#### CARMANAH WALBRAN PARK

PLAN EPP1314

# SURVEY PLAN OF PART OF THE EASTERLY BOUNDARY OF CARMANAH WALBRAN PROVINCIAL PARK. (WALBRAN SITE), RENEWAL DISTRICT.

# Proposed Park/TFL boundary

## **CARMANAH WALBRAN PARK**

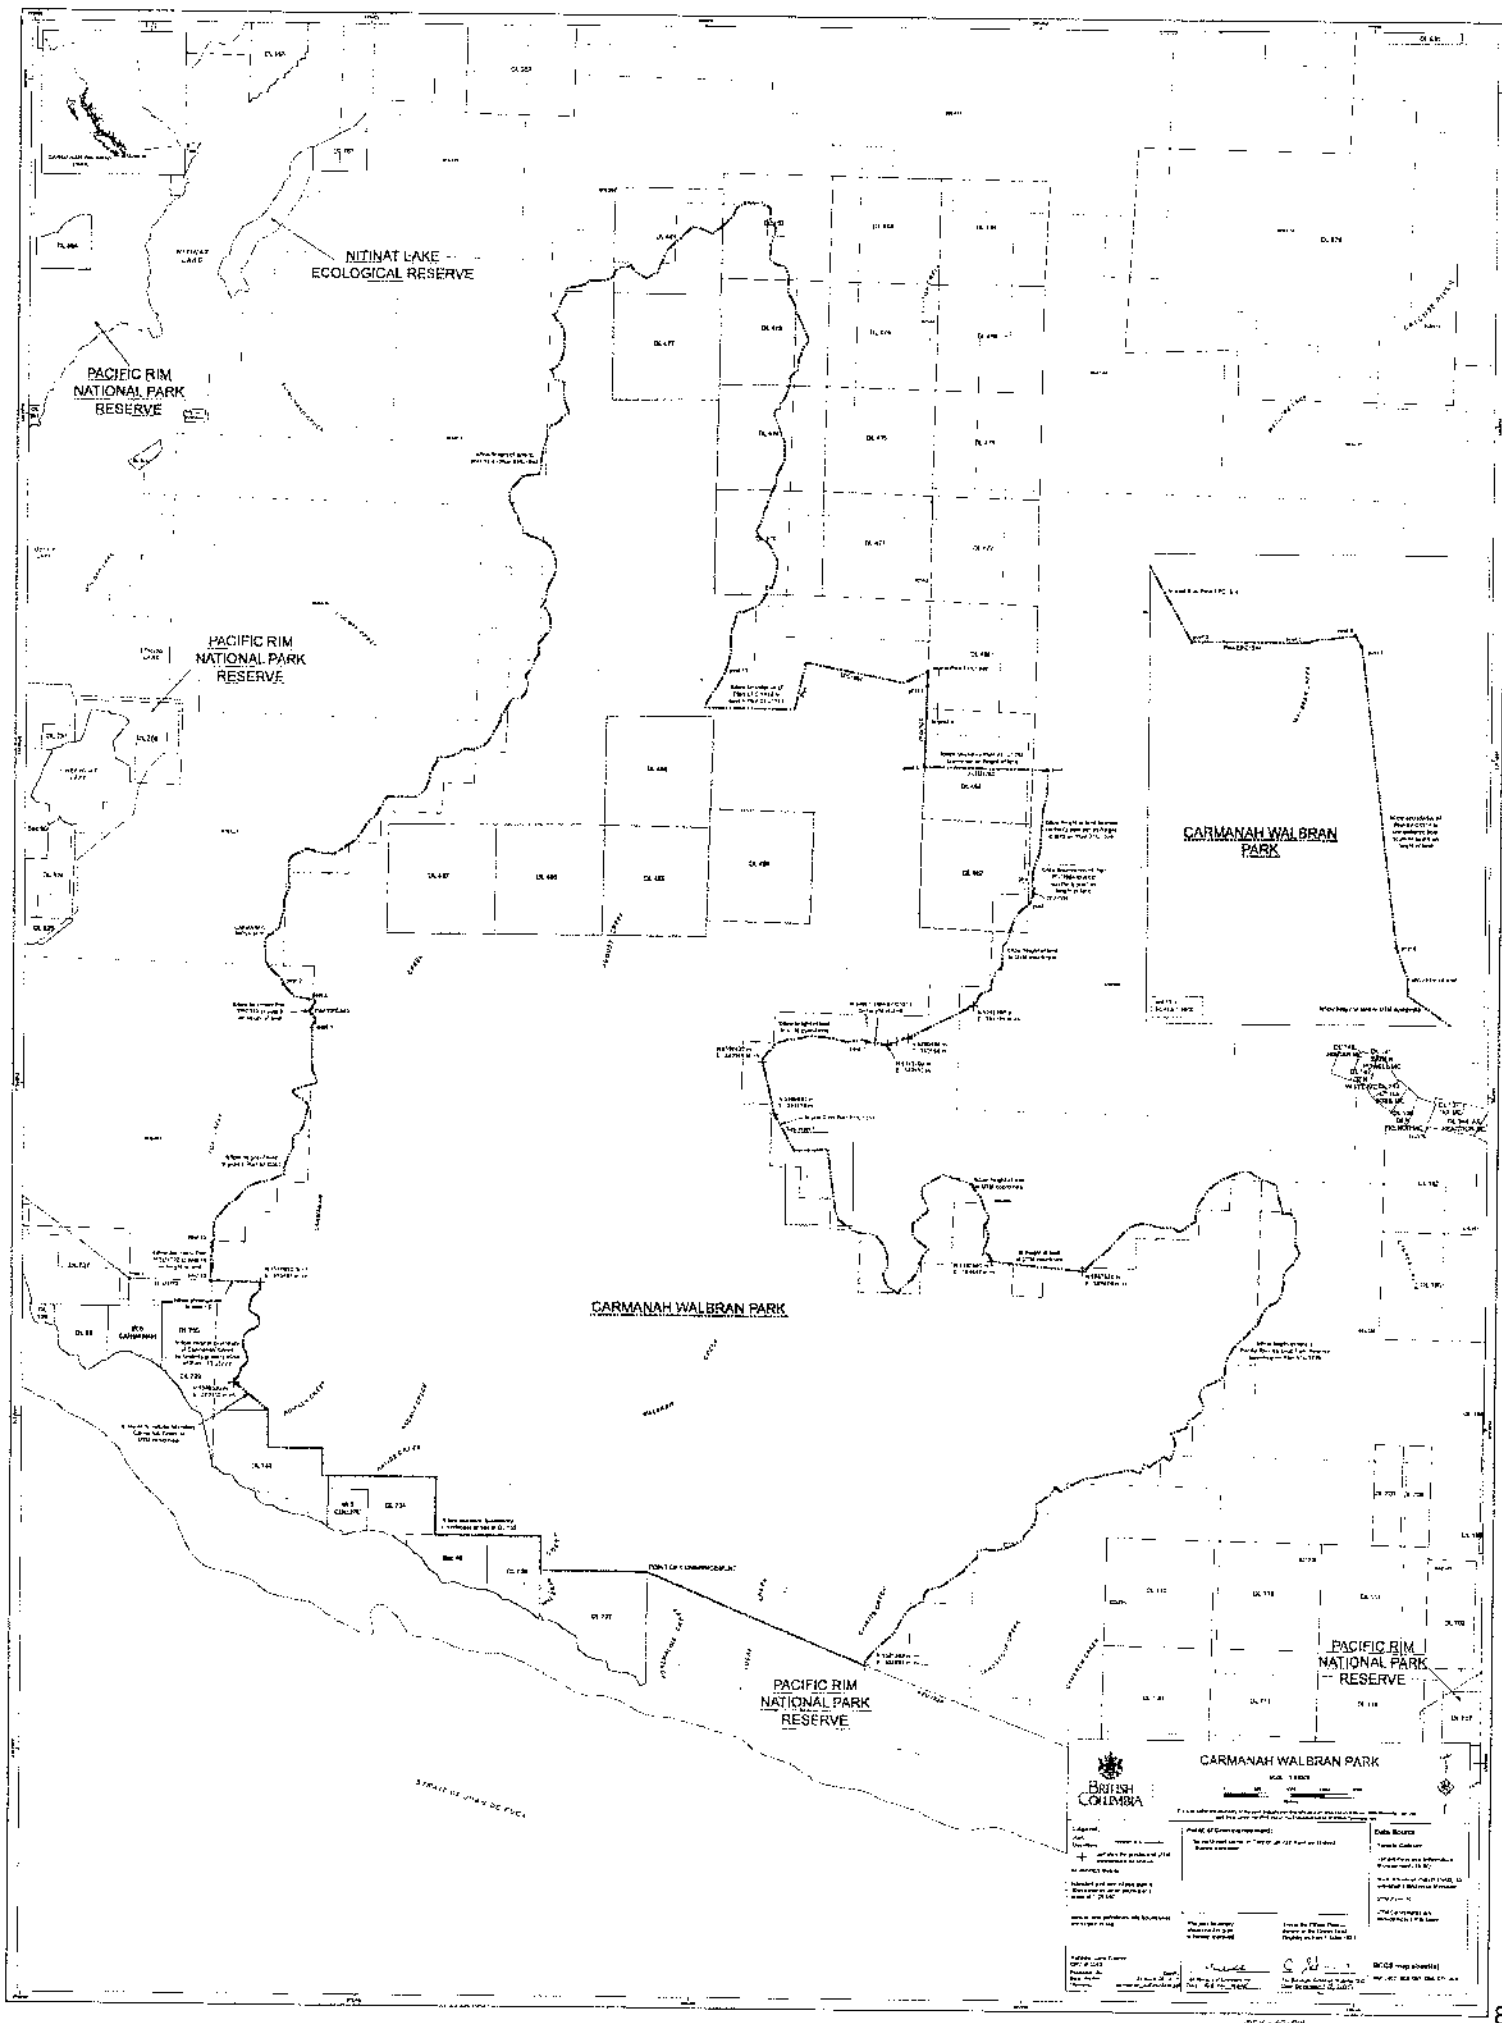
- 
- Replacing the metes and bounds description with an official plan
  - Area updated

All those parcels or tracts of Crown land, together with all that foreshore or land covered by water, situated in Renfrew District and contained within the following-described boundaries: as shown on the Official Plan deposited in the Crown land registry as Plan 1 Tube 1921.

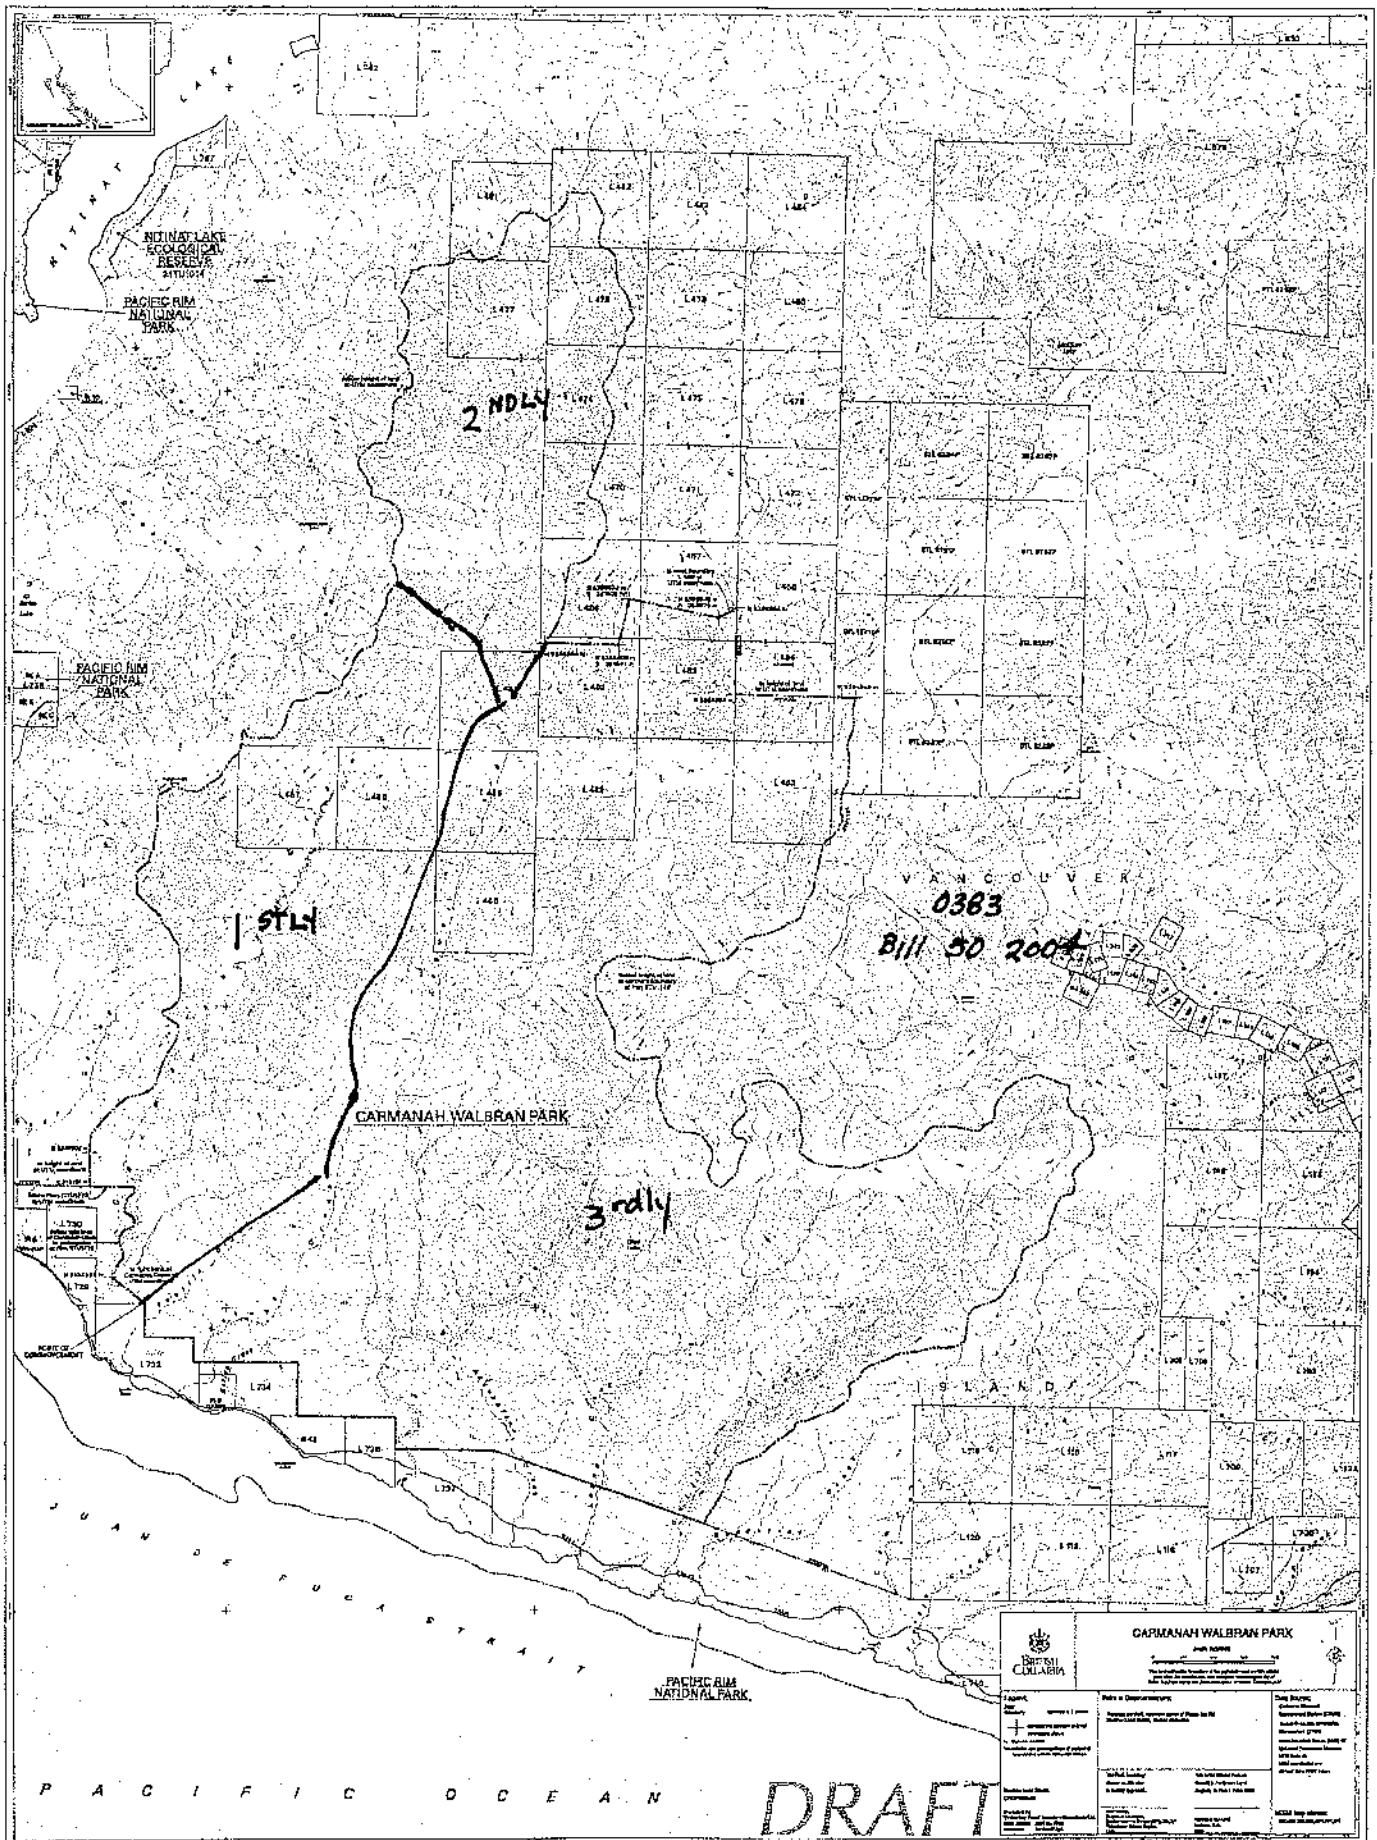
Hi Steve  
Thanks for the voice mail.  
Can you please e-mail to me the map sheet that shows the incorrect coordinate and indicate on that map sheet which coordinate is wrong and what the correct coordinate is.  
I want to ensure that my survey instructions are corrected accordingly and that the correction is accepted by both yourself and the land surveyor.  
If the error that you found is not contained on any of the information that I e-mail out July 02, 2014 at 3:03PM but rather on another document please let me know.

Thanks Steve for the keen eye.  
Rob, can you please review and tell us what is correct. Thanks  
Jeff

In the word text description it is E382850 .....I expect is correct

Since the easting on 'Post 1' is E382540, and the corner in question is 310m+/- to the east of that, then E382850 makes sense.

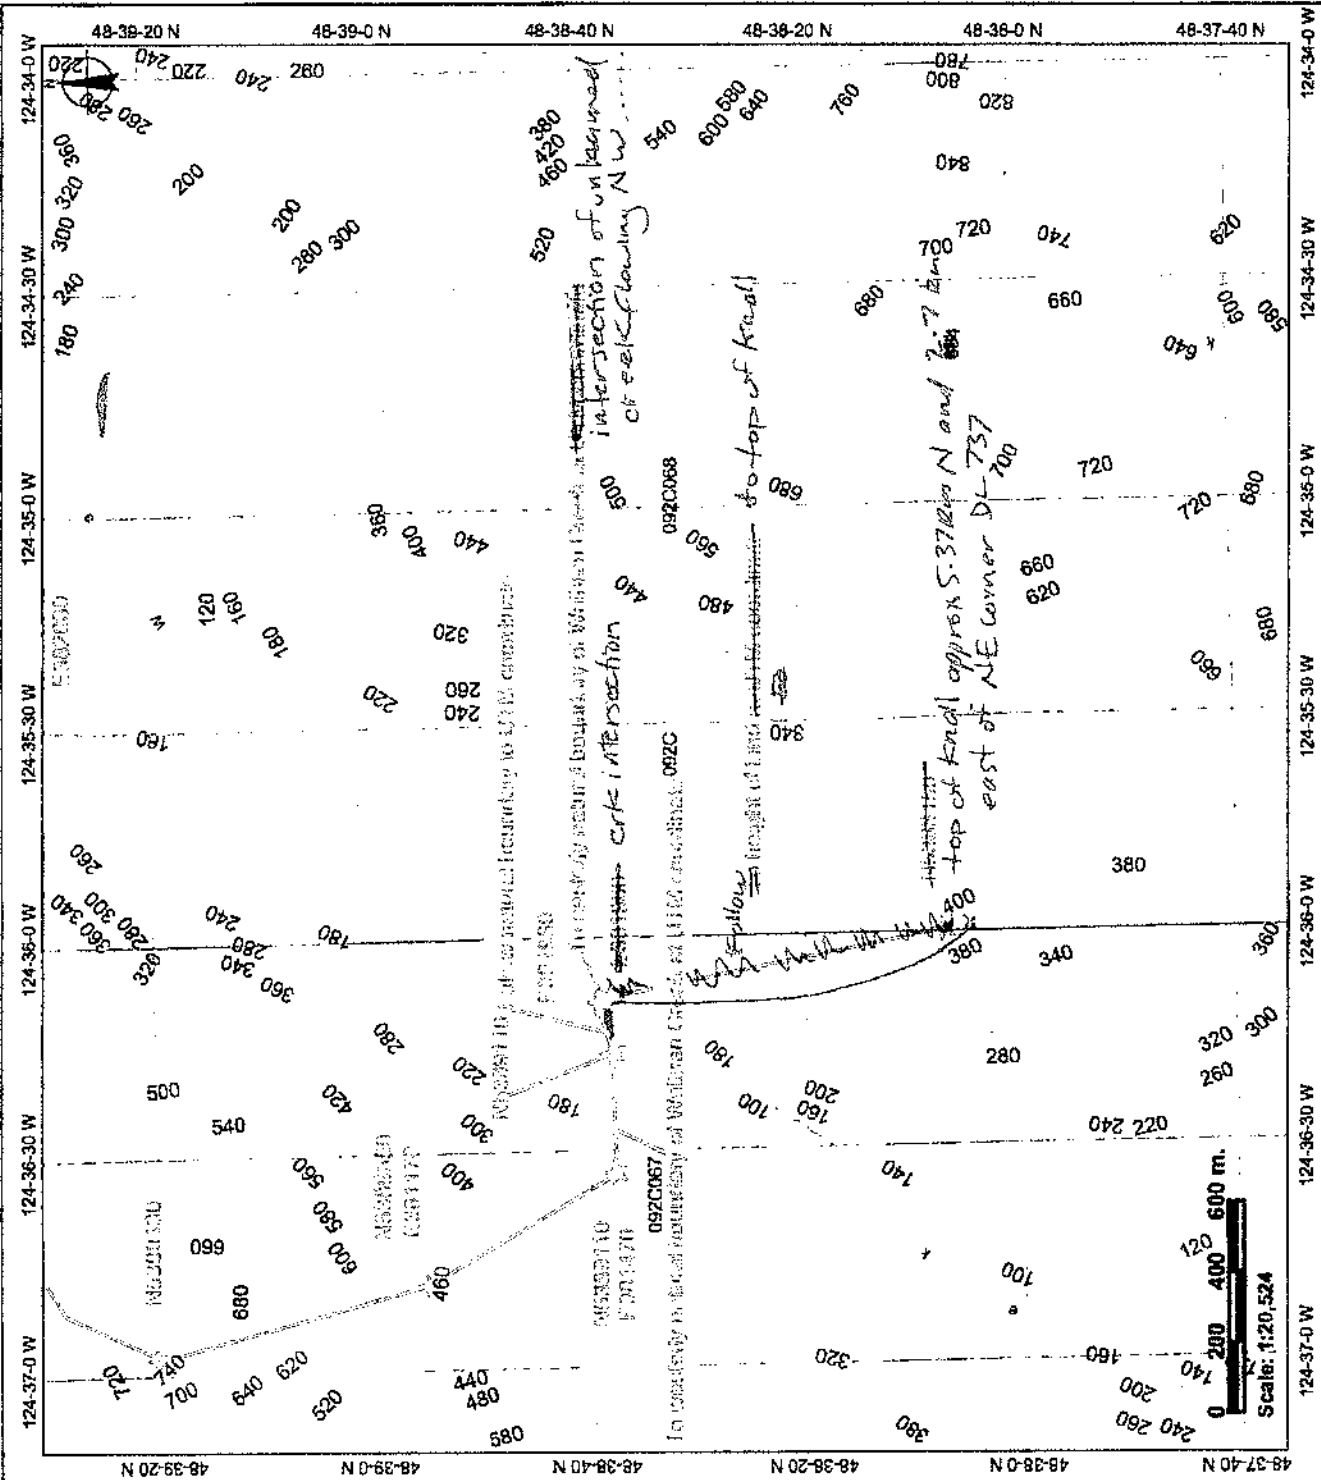
My only suggestion/request is that the southernmost segment of the clarification be changed to follow the height of land. The clarification currently has it as a straight line between the last two described points. This height-of-land appears to be reasonably clear on the map. The change is minimal but will reflect the current mapped version of the boundary and will not conflict with the legislated written description which does not indicate the path taken between the two points (from the creek mouth to the top of the knoll). In fact following the height of land better reflects the written description of the two end points. The northern end point is currently described as the junction of this watershed and the left bank of Walbran Creek and the southern end is described as the top of the knoll which should be the watershed boundary.
